THE SHERWIN-WILLIAMS COMPANY
Environmental, Health & Regulatory Services
101 Prospect Avenue NW
Cleveland, Ohio 44115-1075
Facsimile: (216) 566-2730

RE: Sherwin-Williams/Hilliards Creek Site- Former Manufacturing Plant
Gibbsboro, New Jersey
Administrative Order Index No. II CERCLA-02-99-2035

Response to USEPA and NJDEP May 2, 2012 Comments on
January 20, 2012 *Revised Work Plan for Additional
Groundwater Characterization*

Sounding: CPT-13
Site: Bridgeport, NJ

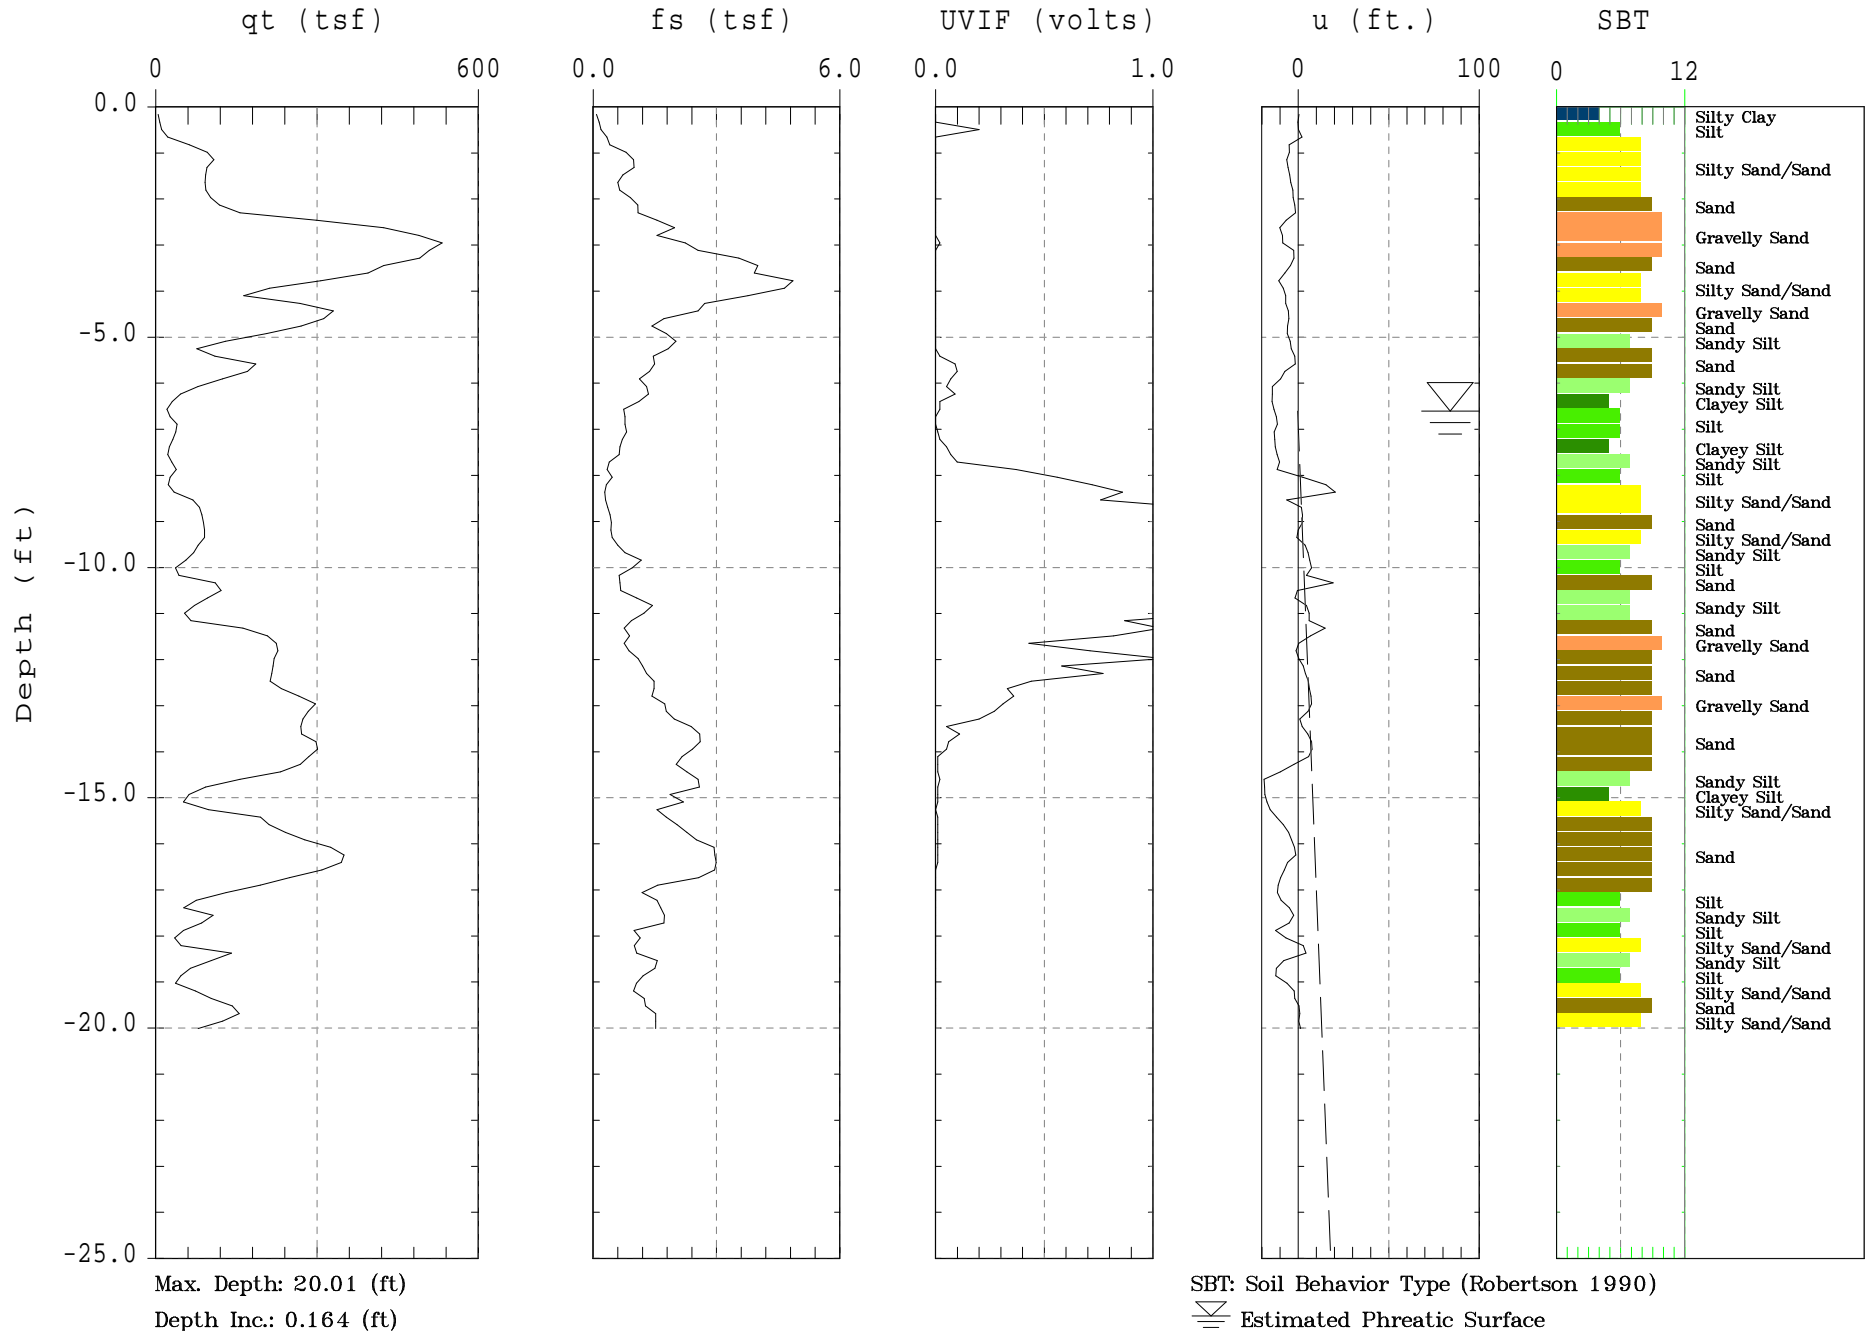
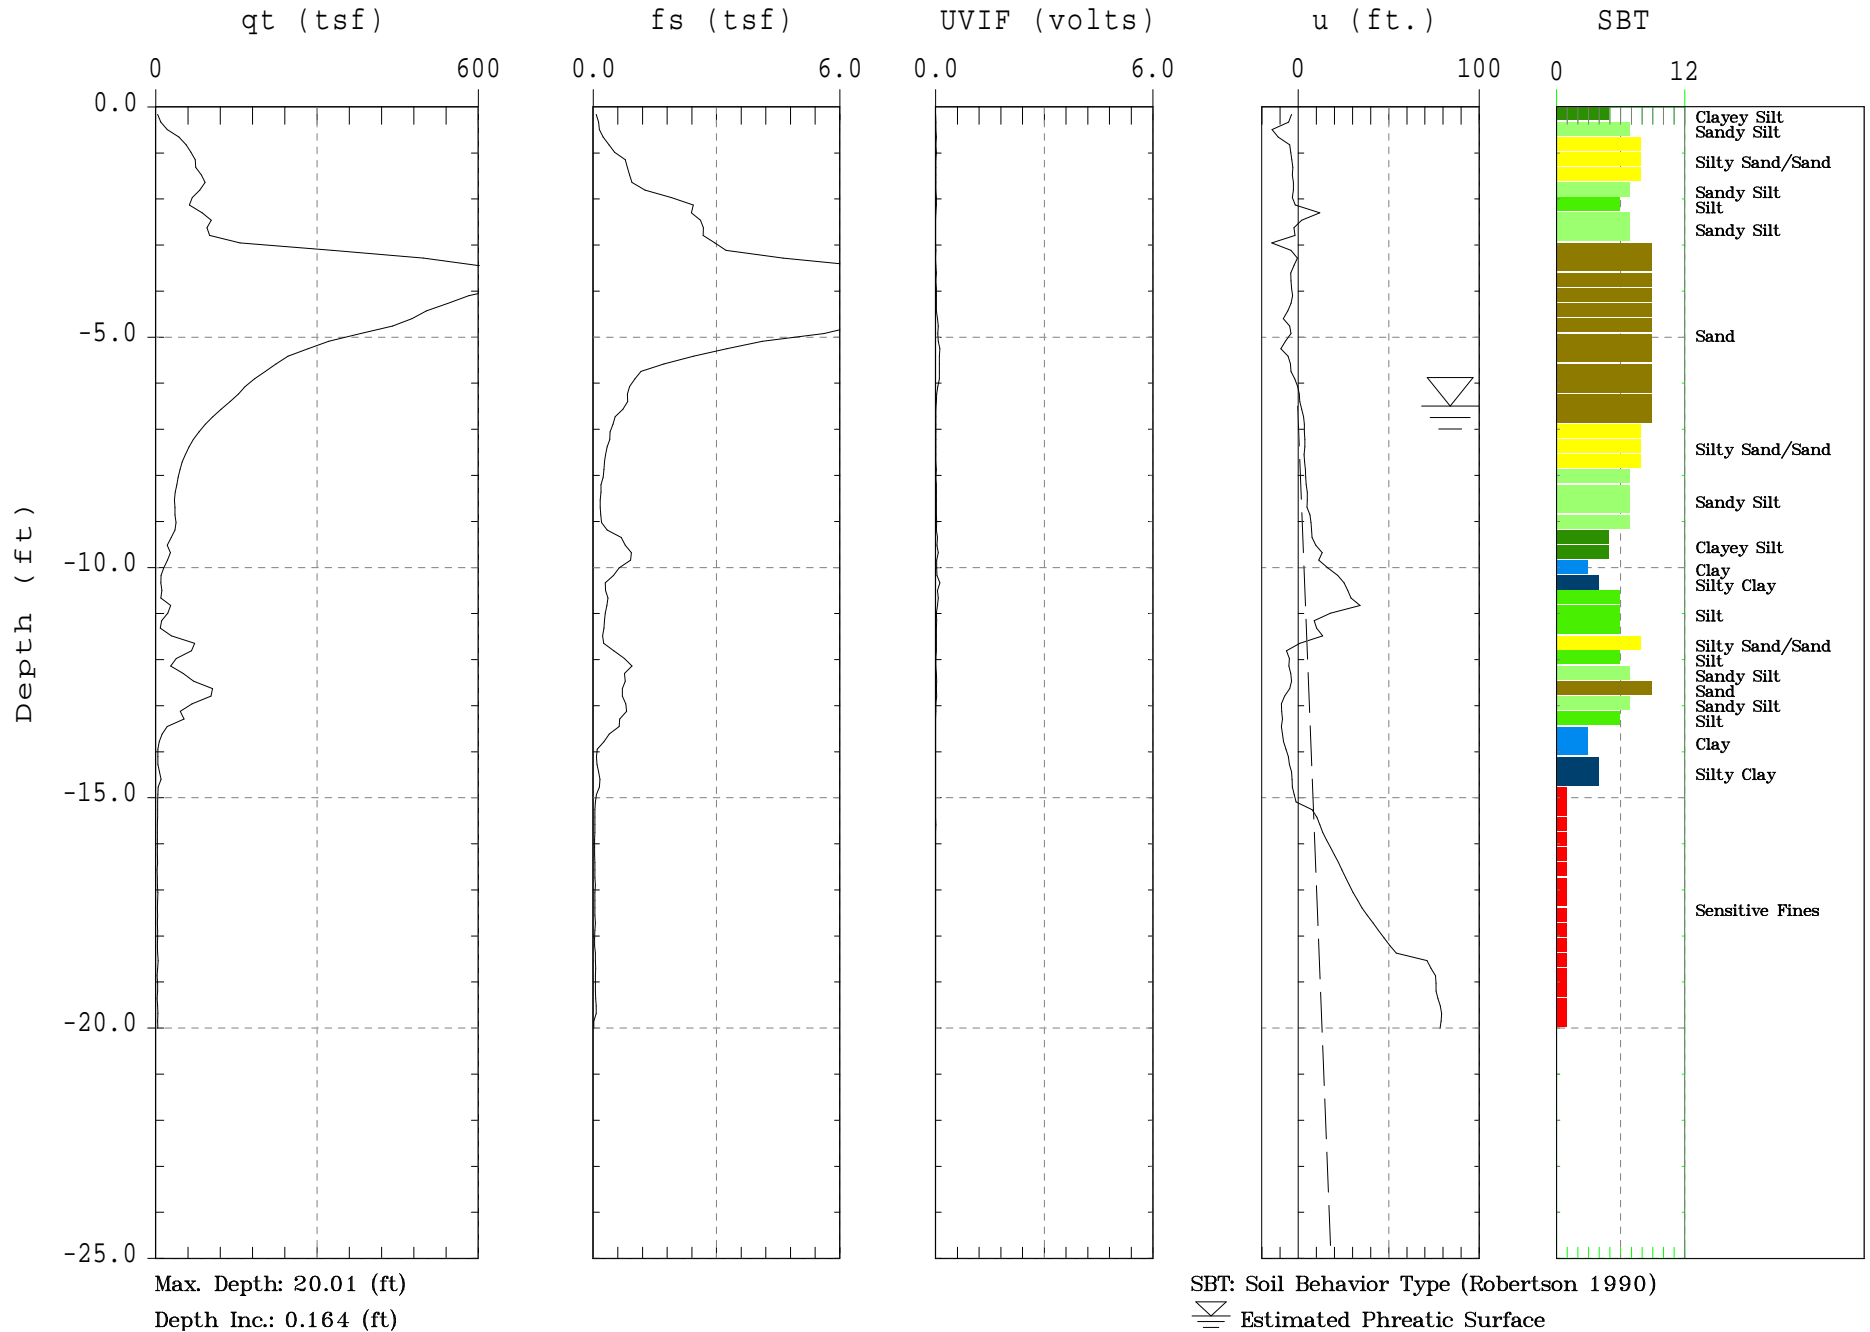
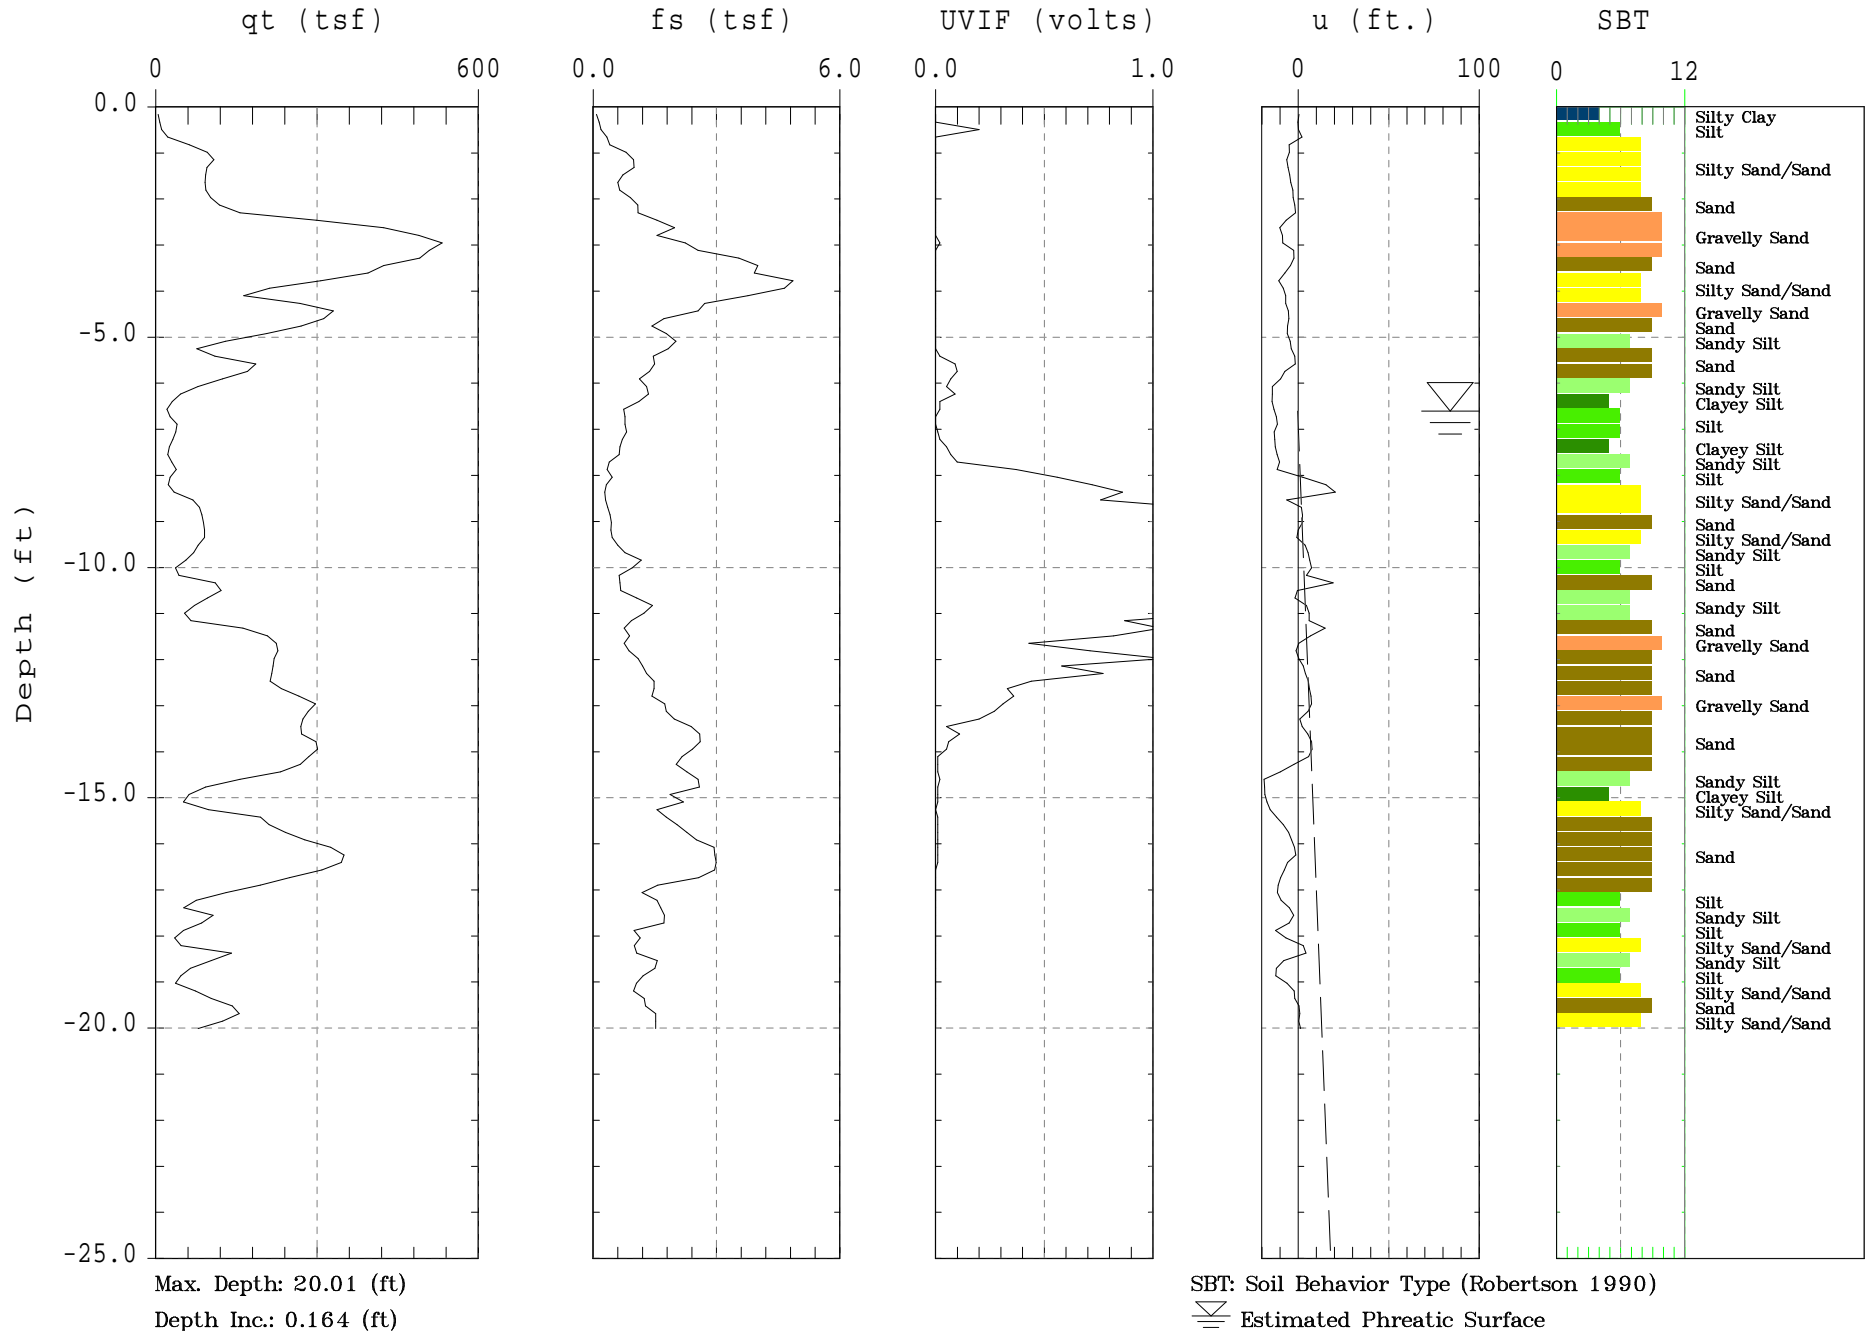
In the other UVIF/LIF log (CPT-13), no real UVIF response was observed. In this case, it may be that the sensitivity was not great enough to detect any petroleum that may be present (the response was set at 6 volts) or there may not have been any significant amount of petroleum in the boring.
